**Economic and Social Council**Distr.: General
30 June 2021

World Forum for Harmonization of Vehicle Regulations**Working Party on Noise and Tyres****Seventy-fourth session**

Tyres: UN Regulation No. 117 (Tyre rolling resistance, rolling noise and wet grip)**Proposal for amendments to UN Regulation No. 117****Submitted by the Informal Working Group on Wet Grip Performance
for Tyres in a Worn State***

“Annex 2 - Appendix 1

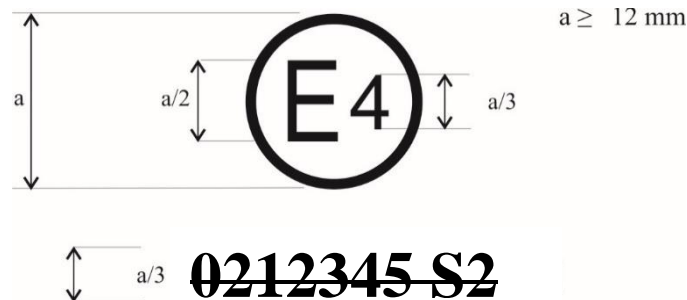
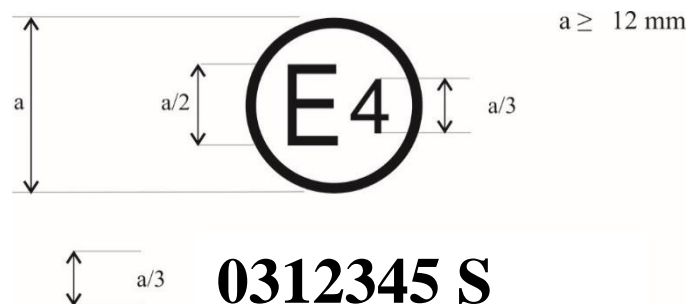
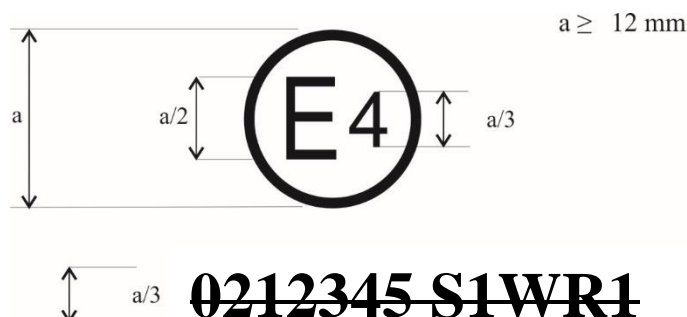
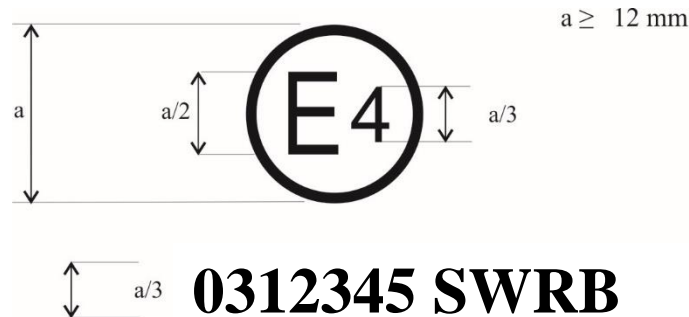
The above approval mark, affixed to a tyre shows that a tyre concerned has been approved in the Netherlands (E 4) pursuant to Regulation No. 117 (marked by S2 (rolling sound at stage 2) only), under approval number 0212345. The first two digits of the approval number (02) indicate that the approval was granted according to the requirements 02-series of amendments to this Regulation.

The above approval mark, affixed to a tyre shows that a tyre concerned has been approved in the Netherlands (E4) pursuant to UN Regulation No. 117 (marked by S (rolling sound)), under approval number 0312345. The first two digits of the approval number (03) indicate that the approval was granted according to the requirements of the 03 series of amendments to this Regulation.

The above approval mark shows that the tyre concerned has been approved in the Netherlands (E 4) pursuant to Regulation No. 117 (marked by S1 (rolling sound at stage 1) W (wet adhesion), and R1 (Rolling resistance at stage 1) under approval number 0212345. This indicates that the approval is for S1WR1. The first two digits of the approval number (02) indicate that the approval was granted according to the requirements of the 02-series of amendments to this Regulation.

The above approval mark shows that the tyre concerned has been approved in the Netherlands (E4) pursuant to UN Regulation No. 117 (marked by S (rolling sound), W (wet adhesion of tyres in new state), R (rolling resistance) and B (wet adhesion of tyres in worn state)) under approval number 0312345. The first two digits of the approval number (03) indicate that the approval was granted according to the requirements of the 03 series of amendments to this Regulation.”

“Annex 2 - Appendix 2

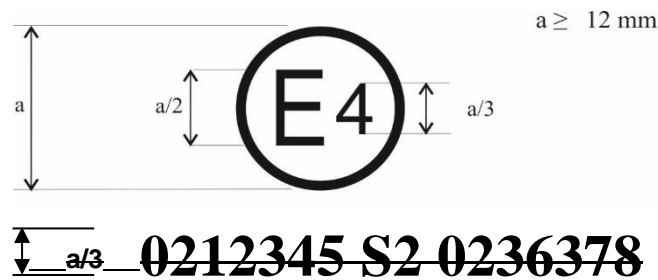
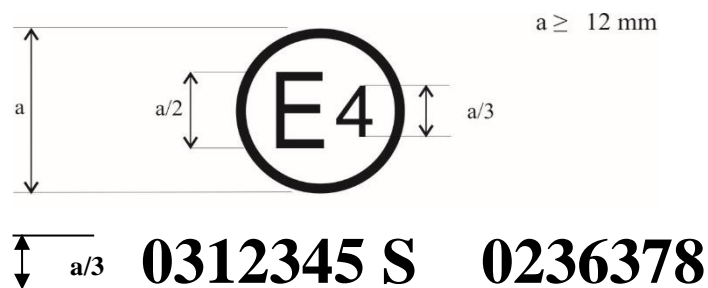
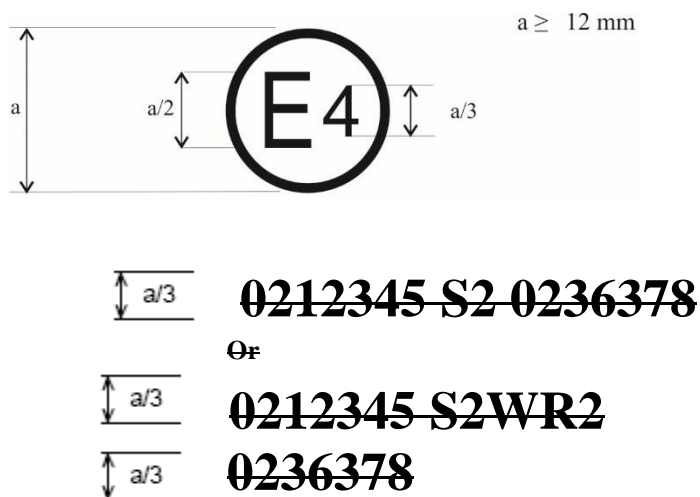
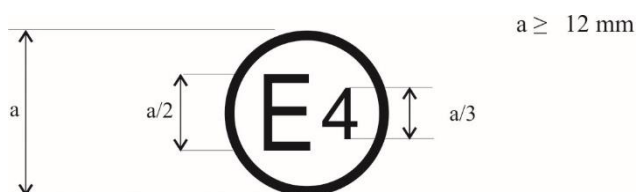
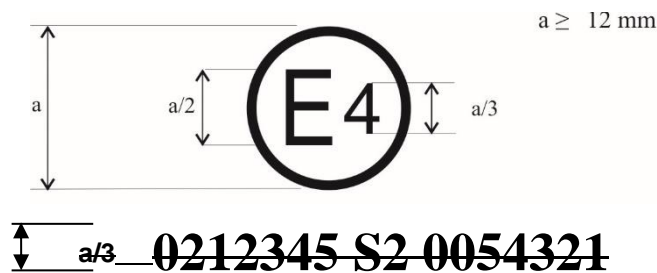
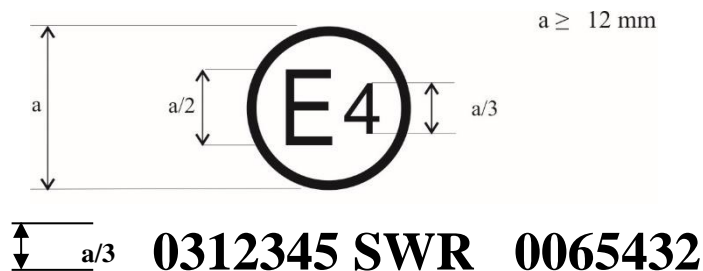
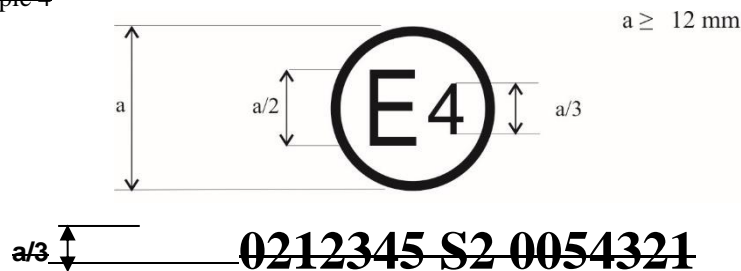
The above approval mark shows that the tyre concerned has been approved in the Netherlands (E 4) pursuant to Regulation No. 117 (marked by S2 (rolling sound at stage 2)), under approval number 0212345 and Regulation No. 30, under approval number 0236378. The first two digits of the approval number (02) indicate that the approval was granted according to the 02-series of amendments and Regulation No. 30 included the 02-series of amendments.

The above approval mark shows that the tyre concerned has been approved in the Netherlands (E4) pursuant to UN Regulation No. 117 (marked by "S" (rolling sound)), under approval number 0312345 and UN Regulation No. 30, under approval number 0236378. The first two digits of the approval numbers ("03" and "02") indicate that the approval pursuant to UN Regulation No. 117 was granted according to the 03 series of amendments and the approval pursuant to UN Regulation No. 30 according to the 02 series of amendments.

The above approval mark shows that the tyre concerned has been approved in the Netherlands (E4) pursuant to Regulation No. 117 (marked by S2WR2 (rolling sound at stage 2 wet adhesion and rolling resistance at stage 2)), under approval number 0212345 and Regulation No. 30 under approval number 0236378. The first two digits of the approval number (02) indicate that the approval was granted according to the 02 series of amendments and Regulation No. 30 included the 02 series of amendments.

The above approval mark shows that the tyre concerned has been approved in the Netherlands (E4) pursuant to UN Regulation No. 117 (marked by "SWRB" (rolling sound, wet adhesion of tyres in new state, rolling resistance and wet adhesion of tyres in worn state)), under approval number 0312345 and UN Regulation No. 30 under approval number 0236378. The first two digits of the approval numbers ("03" and "02") indicate that the approval pursuant to UN Regulation No. 117 was granted according to the 03 series of amendments and the approval pursuant to UN Regulation No. 30 according to the 02 series of amendments.

~~The above approval mark shows that the tyre concerned has been approved in the Netherlands (E4) pursuant to Regulation No. 117 and the 02 series of amendments under approval number 0212345 (marked by S2), and Regulation No. 54. This indicates that the approval is for rolling sound stage 2 (S2). The first two digits of the Regulation No. 117 approval number (02) in conjunction with "S2" indicate that the first approval was granted in accordance with Regulation No. 117 which included the 02 series of amendments. The first two digits of Regulation No. 54 (00) indicate that this Regulation was in its original form.~~

The above approval mark shows that the tyre concerned has been approved in the Netherlands (E4) pursuant to UN Regulation No. 117 (marked by "SWR" (rolling sound, wet adhesion of tyres in new state and rolling resistance)), under approval number 0312345 and UN Regulation No. 54 under approval number 0065432. The first two digits of the approval numbers ("03" and "00") indicate that the approval pursuant to UN Regulation No. 117 was granted according to the 03 series of amendments and the approval pursuant to UN Regulation No. 54 according to its original form.

The above approval mark shows that the tyre concerned has been approved in the Netherlands (E 4) pursuant to Regulation No. 117 and the 02 series of amendments under approval number 0212345 (marked by S2 R2), and Regulation No. 54. This indicates that the approval is for rolling sound stage 2 (S2) and rolling resistance stage 2. The first two digits of the Regulation No. 117 approval number (02) in conjunction with "S2R2" indicate that the first approval was granted in accordance with Regulation No. 117 which included the 02 series of amendments. The first two digits of Regulation No. 54 (00) indicate that this Regulation was in its original form."

“Annex 2 - Appendix 3

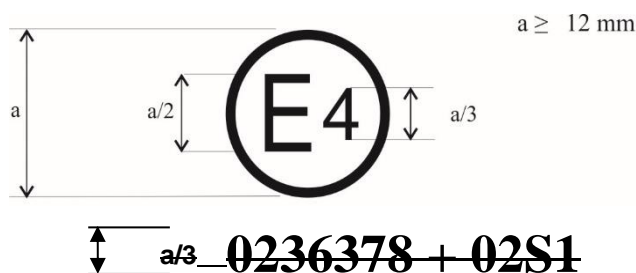
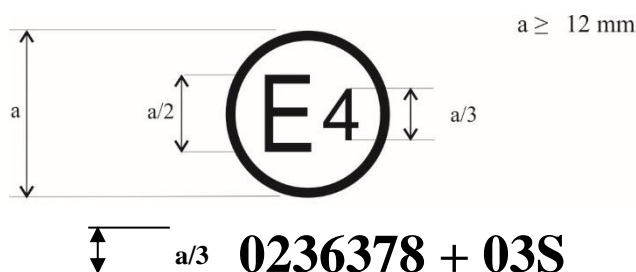
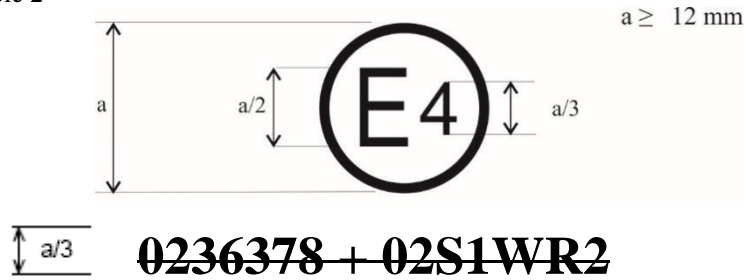
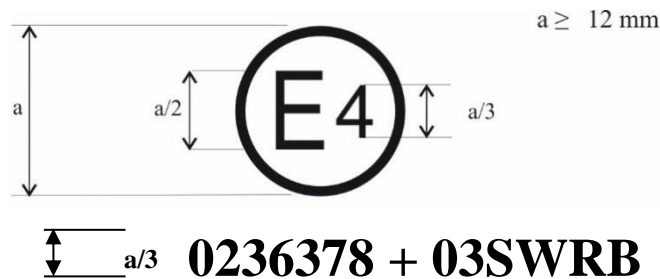
The above approval mark shows that the tyre concerned has been approved in the Netherlands (E 4) pursuant to UN Regulation No. 30 according to its 02 series of amendments (indicated by the first two digits of the approval number, "02") under approval number 0236378. It is also marked by "+ 02S1" which indicates that the tyre was also approved pursuant to UN Regulation No. 117 (02 series of amendments) for rolling sound at stage 1.

The above approval mark shows that the tyre concerned has been approved in the Netherlands (E4) pursuant to UN Regulation No. 30 according to its 02 series of amendments (indicated by the first two digits of the approval number, "02") under

approval number 0236378. It is also marked by "+ 03S" which indicates that the tyre was also approved pursuant to UN Regulation No. 117 (03 series of amendments) for S (rolling sound).

The above approval mark shows that the tyre concerned has been approved in the Netherlands (E4) pursuant to Regulation No. 30 according to its 02 series of amendments under approval number 0236378. It is also marked by "+ 02S1WR2" which indicates that the tyre was also approved pursuant to UN Regulation No. 117 (02 series of amendments) for S1 (rolling sound) W (wet adhesion) and R2 (rolling resistance).

The above approval mark shows that the tyre concerned has been approved in the Netherlands (E4) pursuant to UN Regulation No. 30 according to its 02 series of amendments (indicated by the first two digits of the approval number, "02") under approval number 0236378. It is also marked by "+ 03SWRB" which indicates that the tyre was also approved pursuant to UN Regulation No. 117 (03 series of amendments) for S (rolling sound) W (wet adhesion of tyres in new state), R (rolling resistance) and B (wet adhesion of tyres in worn state)."

“Annex 2 - Appendix 4

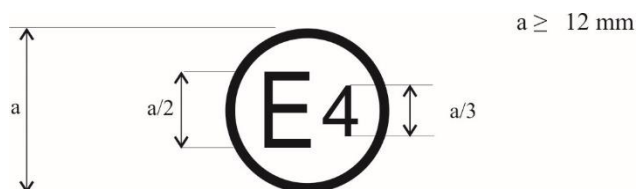
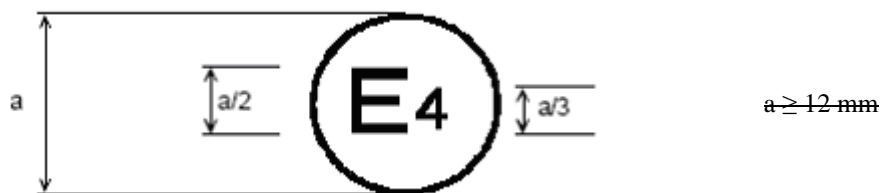
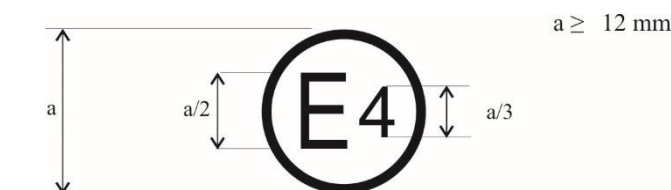
The above approval mark shows that the tyre concerned has been initially approved in the Netherlands (E 4) pursuant to Regulation No. 117 and the 02-series of amendments under approval number 0212345. This indicates that the approval is for W (wet grip). The S2R2 preceded by + indicates that it has had its approval extended under Regulation No. 117 to rolling sound at stage 2 and rolling resistance at stage 2 based on separate certificate(s).

The above approval mark shows that the tyre concerned has been initially approved in the Netherlands (E4) pursuant to UN Regulation No. 117 and the 02 series of amendments under approval number 0212345. The marking is complemented by S2WR2 (rolling sound at stage 2) W (wet adhesion of tyres in new state) and R (rolling resistance at stage 2) The "03B" preceded by "+" indicates that it has had its approval extended under UN Regulation No. 117 and 03 series of amendments to wet adhesion of tyres in worn state based on separate certificate.

The above approval mark shows that the tyre concerned has been initially approved in the Netherlands (E 4) pursuant to Regulation No. 117 and the 02-series of amendments under approval number 0212345. This indicates that the approval is for S1 (rolling sound at stage 1) and W (wet grip). The R1 preceded by + indicates that it has had its approval extended under Regulation No. 117 to rolling resistance at stage 1 based on separate certificate(s).

~~The above approval mark shows that the tyre concerned has been initially approved in the Netherlands (E-4) pursuant to Regulation No. 117 and the 01 series of amendments under approval number 0167890. This indicates that the approval is for S (rolling sound at stage 1) and W (wet grip). The 02R1 preceded by + indicates that it has had its approval extended under Regulation No. 117 and the 02 series of amendments to rolling resistance at stage 1 based on separate certificate(s)."~~
